Re: **Response to IDEM Comments to the Remediation Work Plan
Michigan Plaza**
3801-3823 West Michigan Street
Indianapolis, Indiana 46204
IDEM Incident # 0000198
MUNDELL Project No. M01046

This *Remediation Work Plan Letter Response* is being submitted to the Indiana Department of Environmental Management (IDEM) by MUNDELL & ASSOCIATES, INC. (MUNDELL), on behalf of AIMCO, as a response to IDEM's letter dated May 27, 2008. Additional activities have been performed by MUNDELL to address many of the outstanding items detailed in IDEM's letter (dated May 27, 2008). There are a few remaining items we have proposed for IDEM's consideration pursuant to gathering the data necessary to address the remaining concerns of IDEM. This additional data will ultimately be compiled into a Remediation Work Plan Addendum I Report as requested. Please find the following responses and proposed remaining activities MUNDELL seeks to discuss in a meeting upon your review and earliest convenience;

**Groundwater Analytical Results
Cemetery Property (August 2008)**

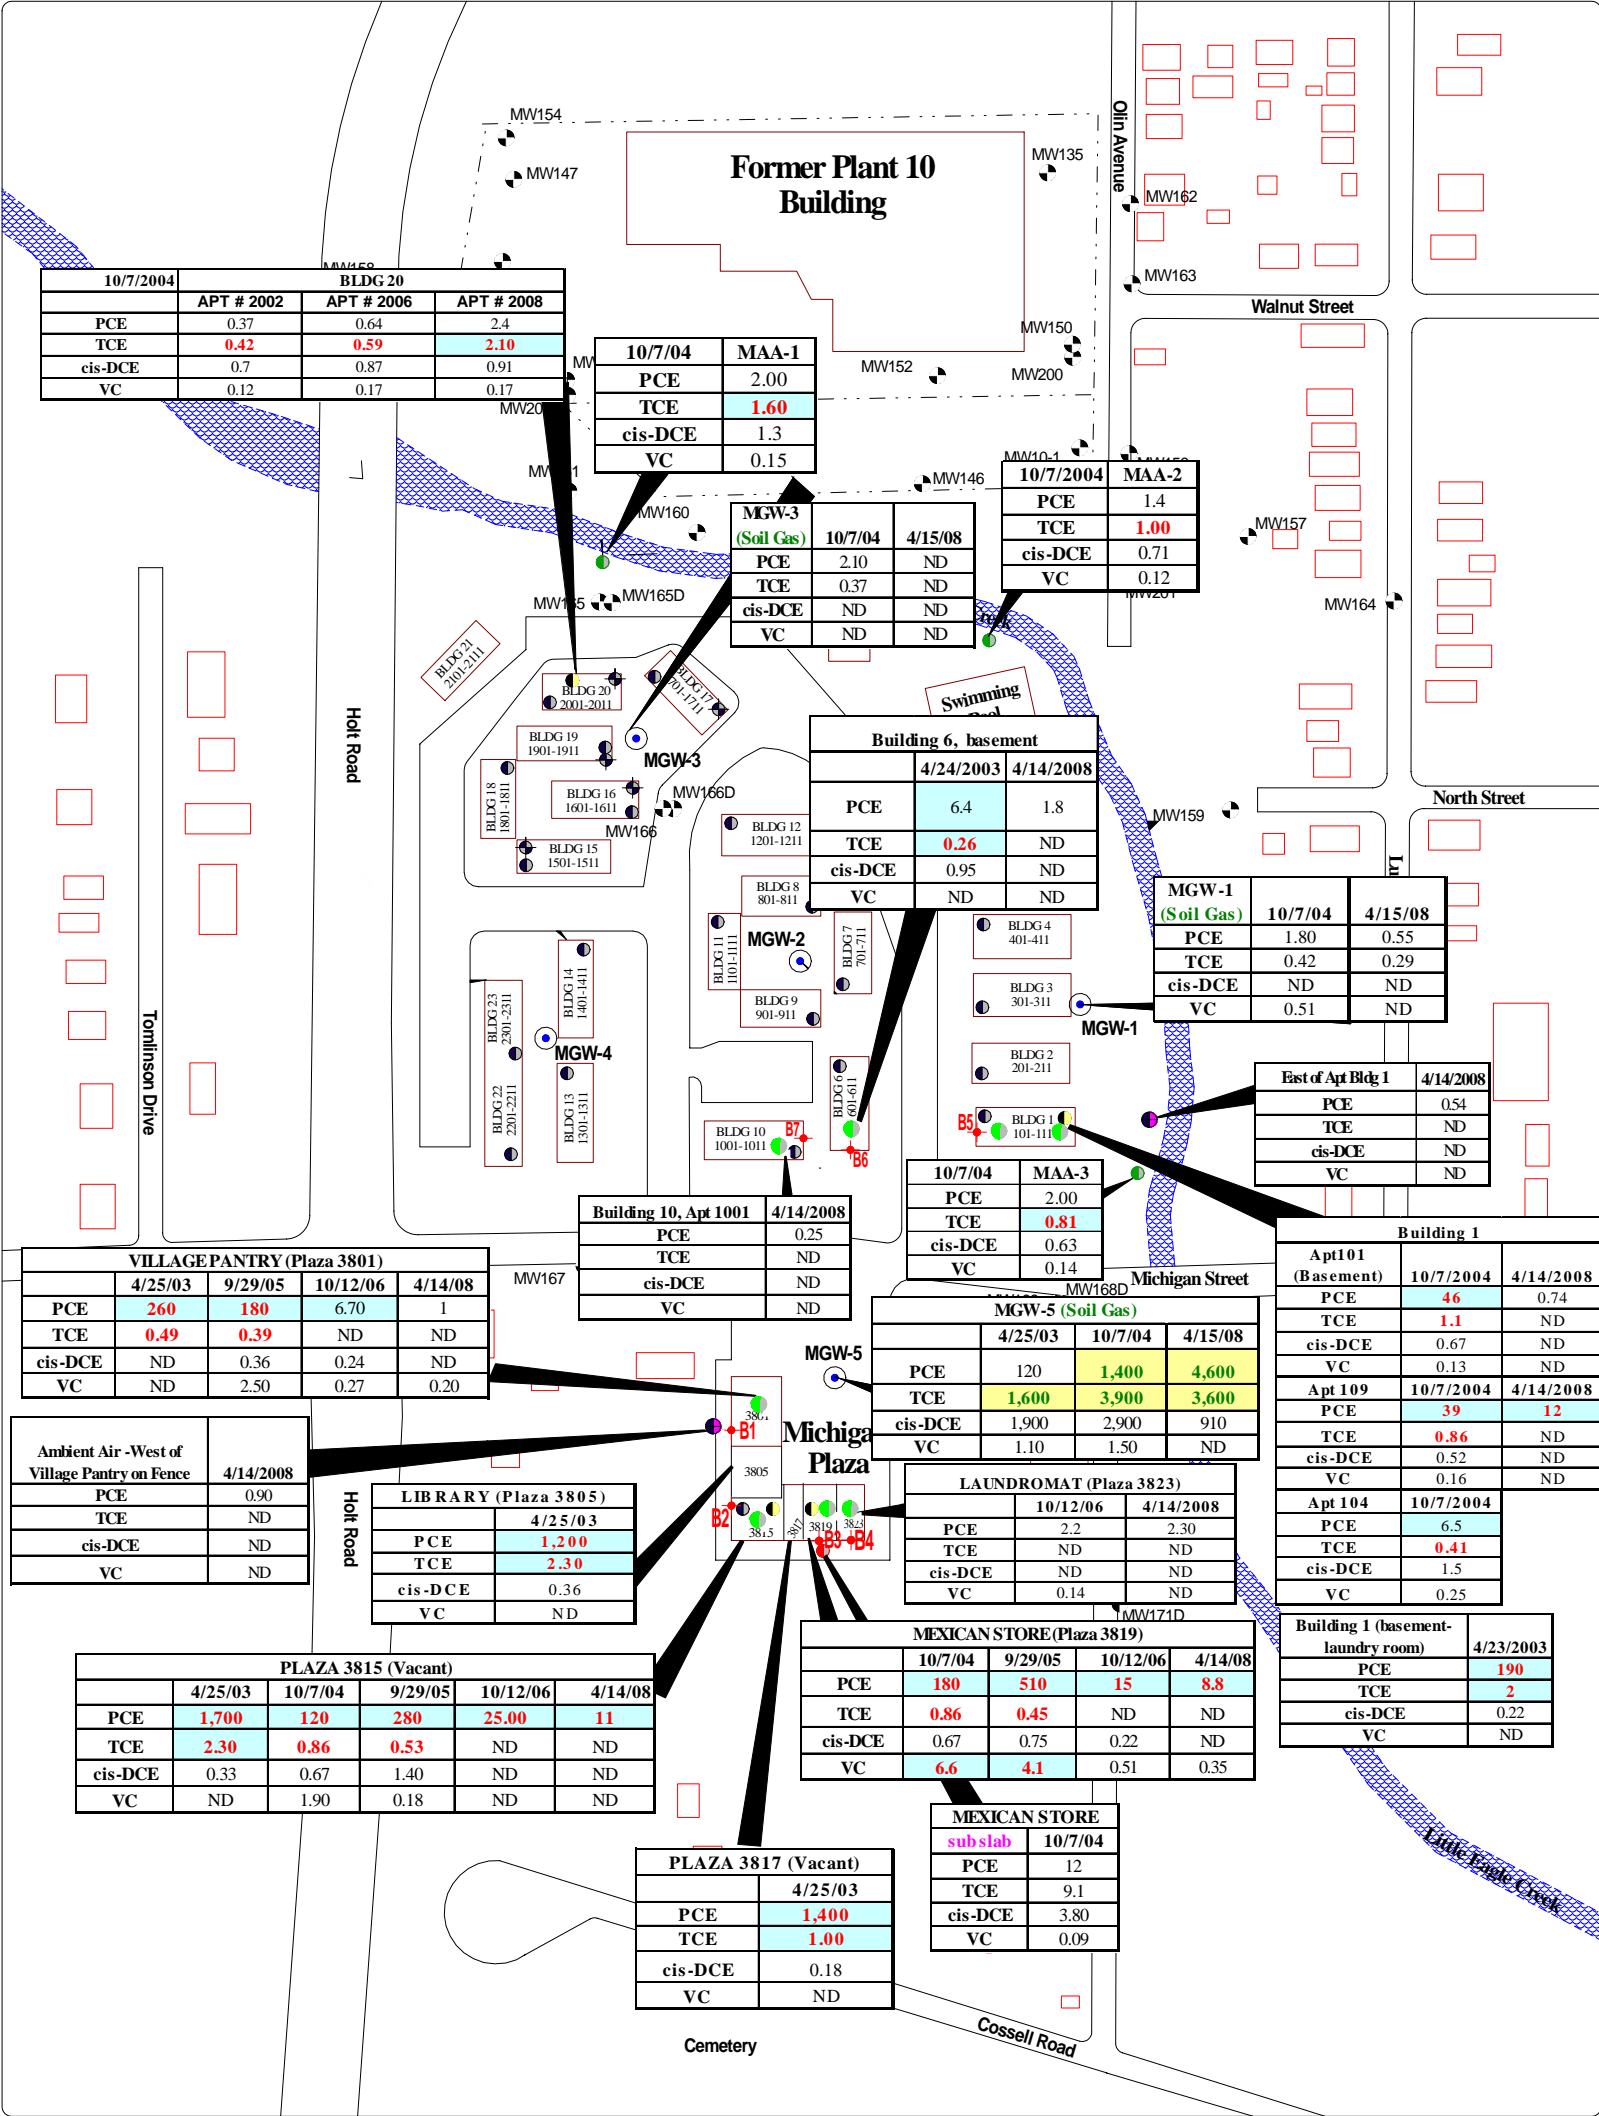
IDEM Comment No. 2. The extent of groundwater contamination has not been defined. The IDEM agrees with the placement of the monitoring well west of MW-171S and MW-171D once access is granted on the Floral Park Cemetery property. Also, please update the figures in the RWP with the newly constructed Floral Park Cemetery building, which is directly south of Michigan Plaza.

MUNDELL Response: MUNDELL drilled at the Cemetery in August and did find shallow PCE impacts just south of the plaza property line on Cemetery property, but not extensively toward our further downgradient wells. MUNDELL has installed two (2) shallow monitoring wells to further delineate the known PCE plume area, and upon receipt of the next round of groundwater sampling, anticipate motioning to sample the further downgradient monitoring wells (MMW-P-09D and MMW-P-09S) only annually.

Figure 2 is attached which illustrates the geoprobe groundwater sampling results from the testing described above. The data shows a definitive increase in VC as the borings test deeper, which reconfirms Genuine impacts at a deeper level in the aquifer. The newly constructed Floral Park Funeral Center is actually further west of the area depicted in our RWP figures, so it is not included.
